AGENDA
CASCADE CHARTER TOWNSHIP PLANNING COMMISSION
MONDAY, July 7, 2025
6:00PM
2870 JACKSMITH AVE SE

STAFF REPORT: Case # 25-3890
REPORT DATE: July 2, 2025
PREPARED FOR: Cascade Charter Township Planning Commission
MEETING DATE: July 7, 2025
PREPARED BY: Andrea Hendrick, Community Planning & Development Director

STAFF REPORT: Case # 25-3888
REPORT DATE: July 2, 2025
PREPARED FOR: Cascade Charter Township Planning Commission
MEETING DATE: July 7, 2025
PREPARED BY: Andrea Hendrick, Community Planning & Development Director

A1

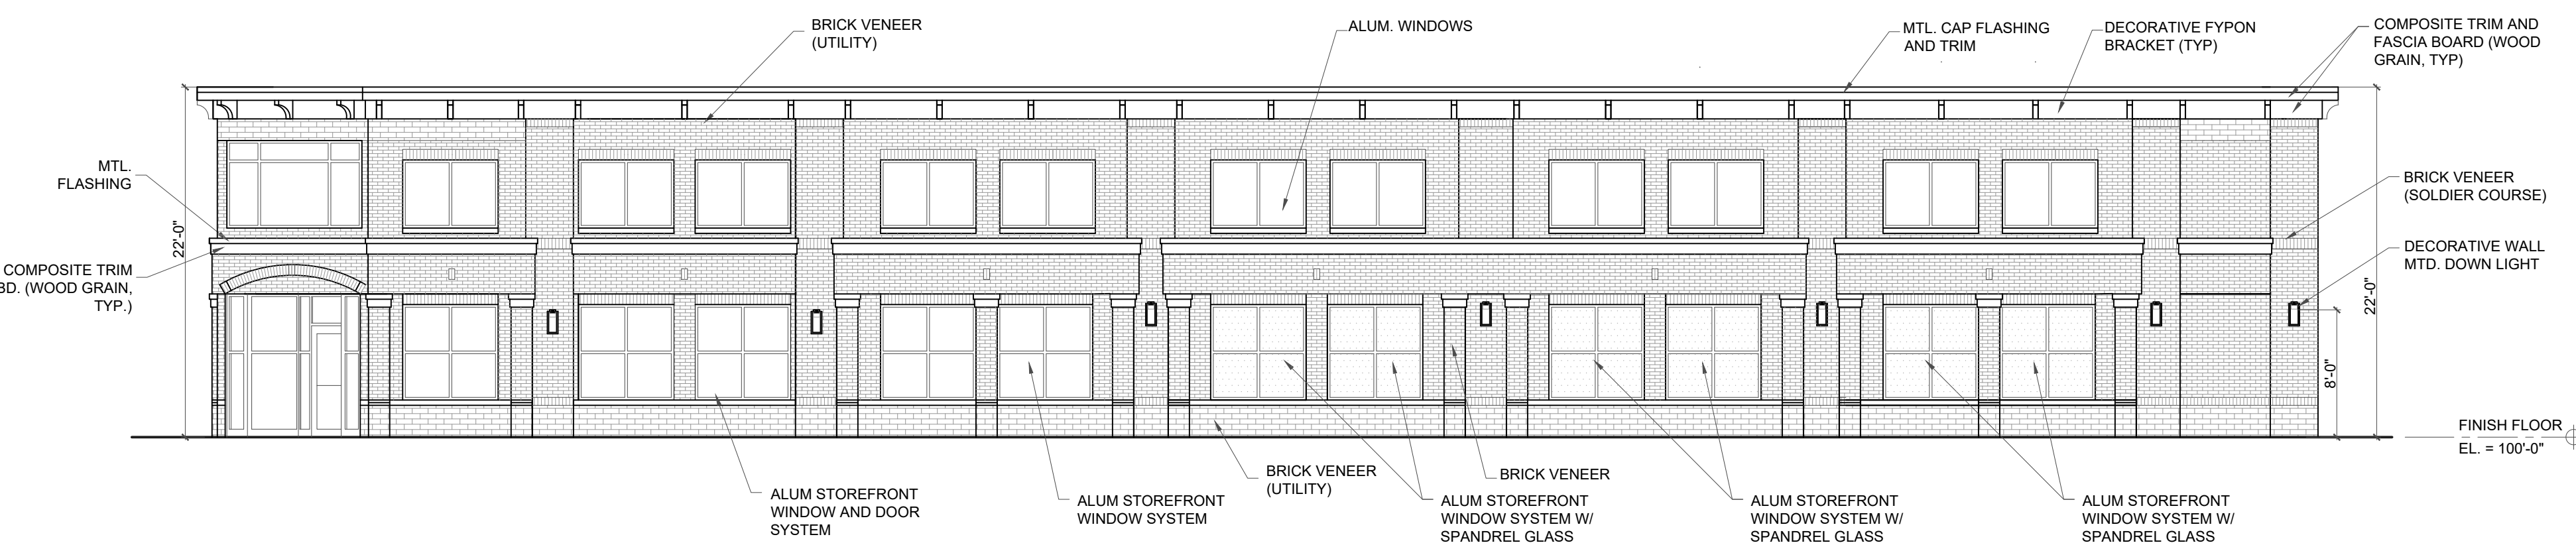
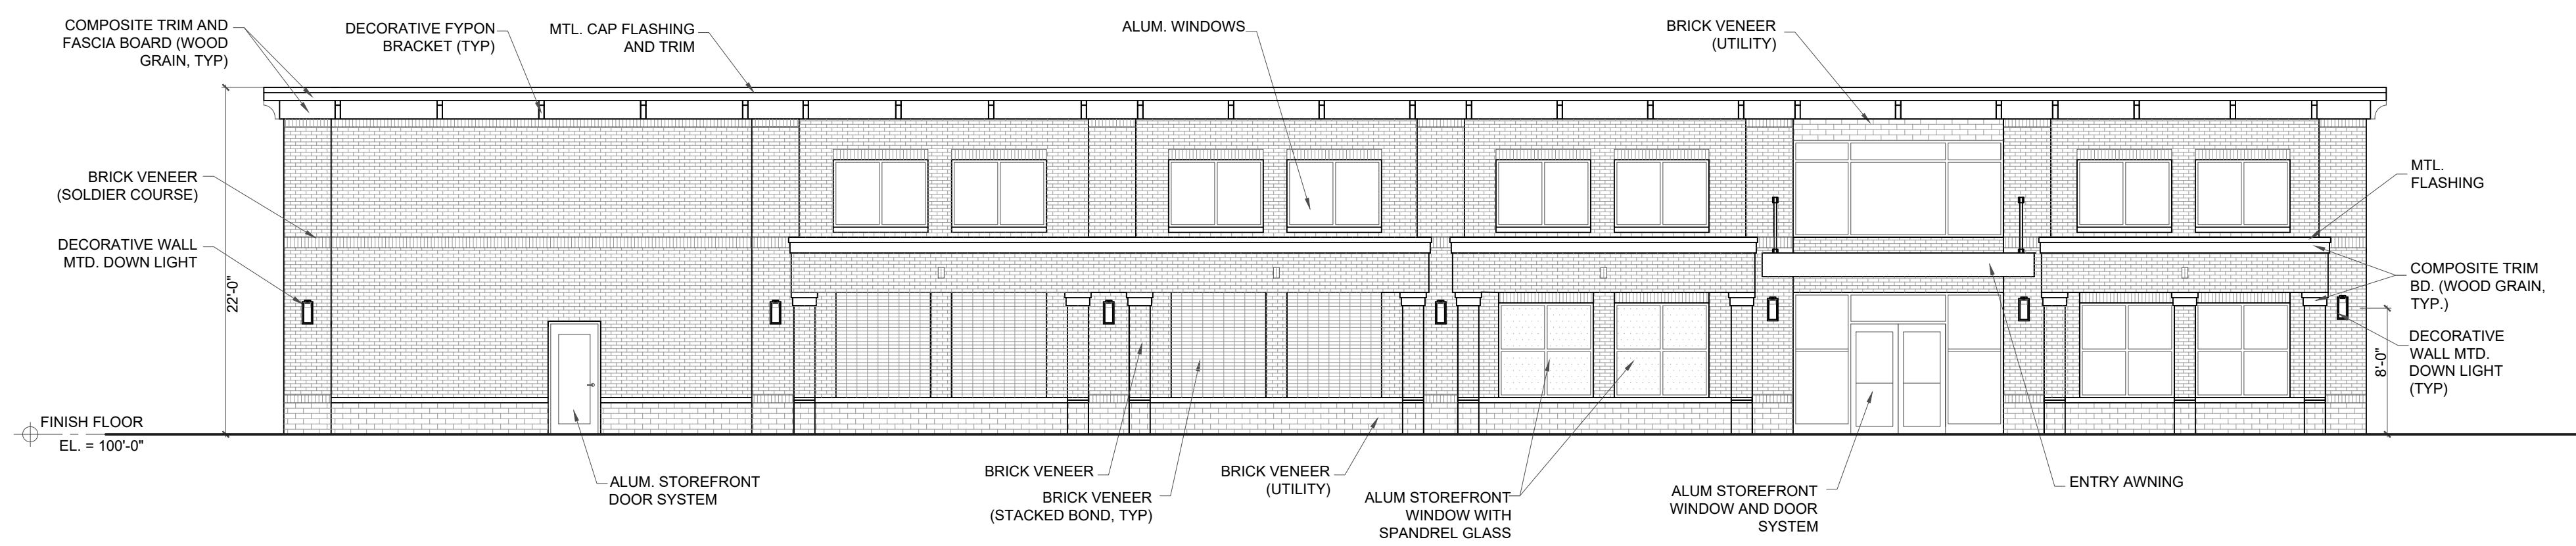
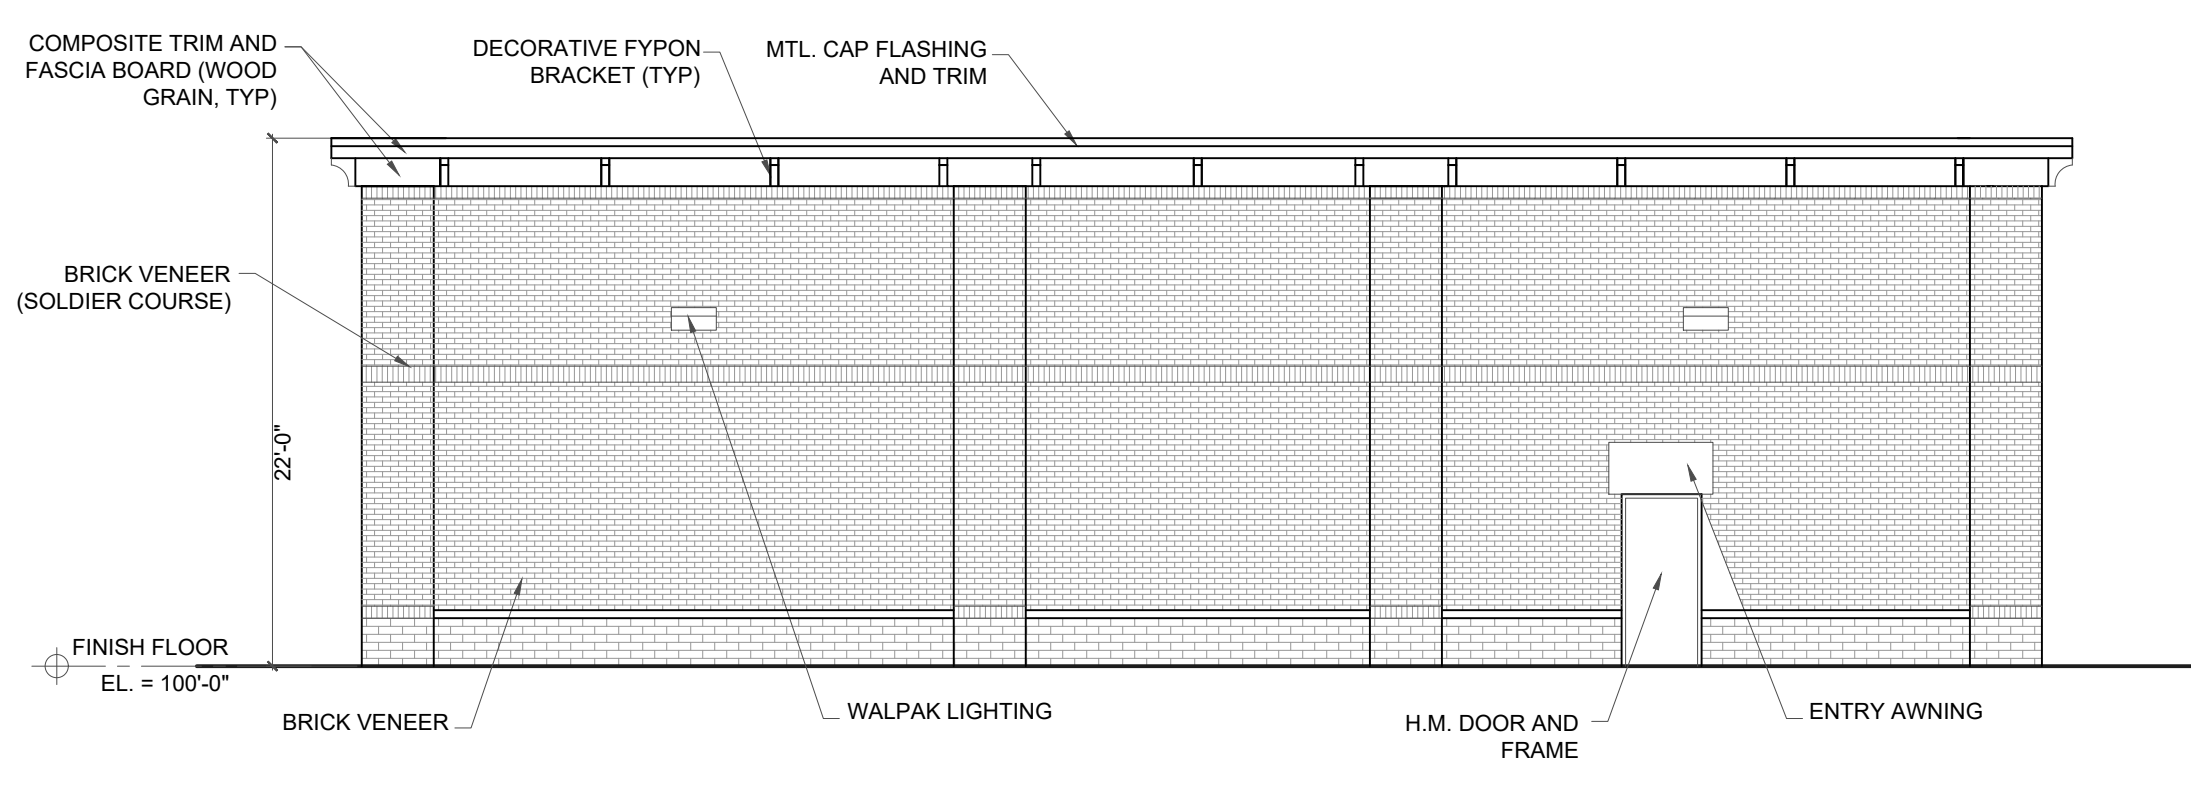
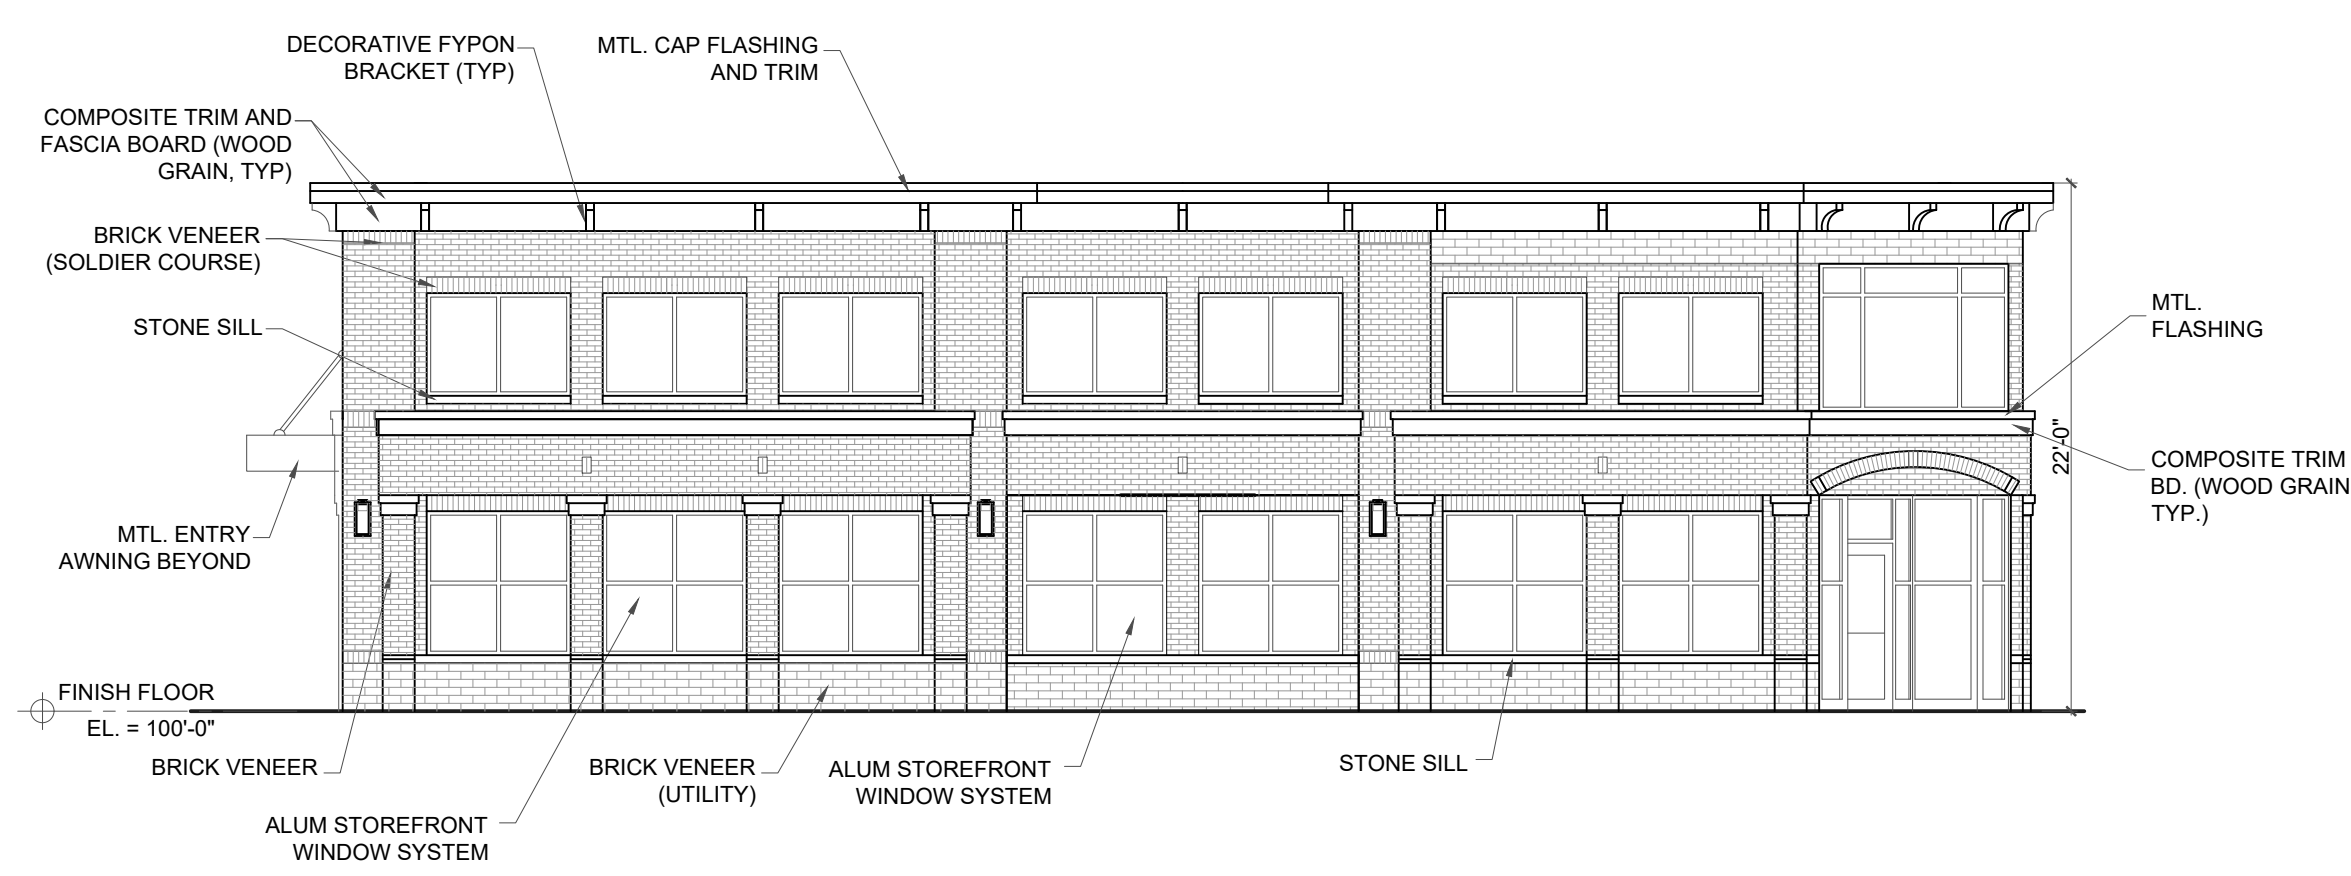
| Brick. Typically red, brown, blonde, or tan clay brick. Can feature painted or glazed surfaces. Often arranged in Flemish bond or running bond patterns, though other patterns may be approved by the Planning Commission. For a Main Street building, | <i>The applicant has proposed over 90% brick veneer on all four sides of the development. The proposed color of Brick is indicated on Sheet A1.</i> |

| <p>at least 80% of the front facade must be brick or a brick-like material approved by the Planning Commission.</p> <p>There must be a predominant brick color. Other colors shall only be used for Horizontal Expression lines, accenting doors and windows, and other detailing as approved by the Planning Commission.</p> <p>Stone: Limestone or sandstone used for lintels, sills, and decorative banding. Granite or marble are also acceptable. Stone should be used at the bottom of buildings, with brick above.</p> <p>Metalwork: For architectural detailing only.</p> | <p><i>Stone sills, as well as aluminum flashing, are used throughout the building for architectural detailing. Brick patterns for accents throughout the street frontages are consistent with the architectural style of the Main Street Building Type. Additionally, the applicant took feedback from the subcommittee and added burgundy flashing which compliments the brick, adding to the visual appeal of the building.</i></p> <p><i>Wood grain composite trim is proposed as accent material in a few locations. Staff wants to point out that the material proposed is not currently allowed for the building design. While a modification of material standards is allowed, the Planning Commission should view the materials and determine if it is appropriate.</i></p> <p><u><i>The applicant will provide samples for review to the Planning Commission to aid in the decision making.</i></u></p> |

| <p>b. Street-Facing Facades: The following shall apply to street facing facades:</p> <ul style="list-style-type: none"> i. Required First Floor Transparency Percentage (Windows and Glass Doors): Main Street: 70% ii. Required Upper Floor Transparency Percentage (Windows): Main Street: 40% | <p><i>The street facing transparency requirements for Cascade are met. The Orange Street façade meets the requirement for the amount of windows present, however, all windows are not transparent. The VRDC and staff find that the provided façade design meets the spirit of the Ordinance. The Planning Commission has the discretion to wave up to three (3) of the design requirements. A waiver for this provision is recommended.</i></p> |

- Transparency requirements
- Building material – The Planning Commission should consider the wood grain specifically and discuss the draft motion provision #2 and Condition #6 to determine the appropriate language.
- On site lighting
- Utility requirements

1. The VLT levels of the windows be approved by the Planning Department in advance of a building permit.
2. All lighting on site shall be calculated in the photometric and reviewed and approved by the Planning Director.
3. Lighting levels meet the requirements of Article 12.
4. The site shall be connected to water and sewer in compliance with Chapter 313 of the Cascade General Code.
5. An updated Storm Water & Sewer Maintenance Plan be recorded and provided to the township
6. **[IF EXCLUDED in provision 2]** The wood grain composite trim shall be replaced with an approved material for a Main Street Style Building Design.
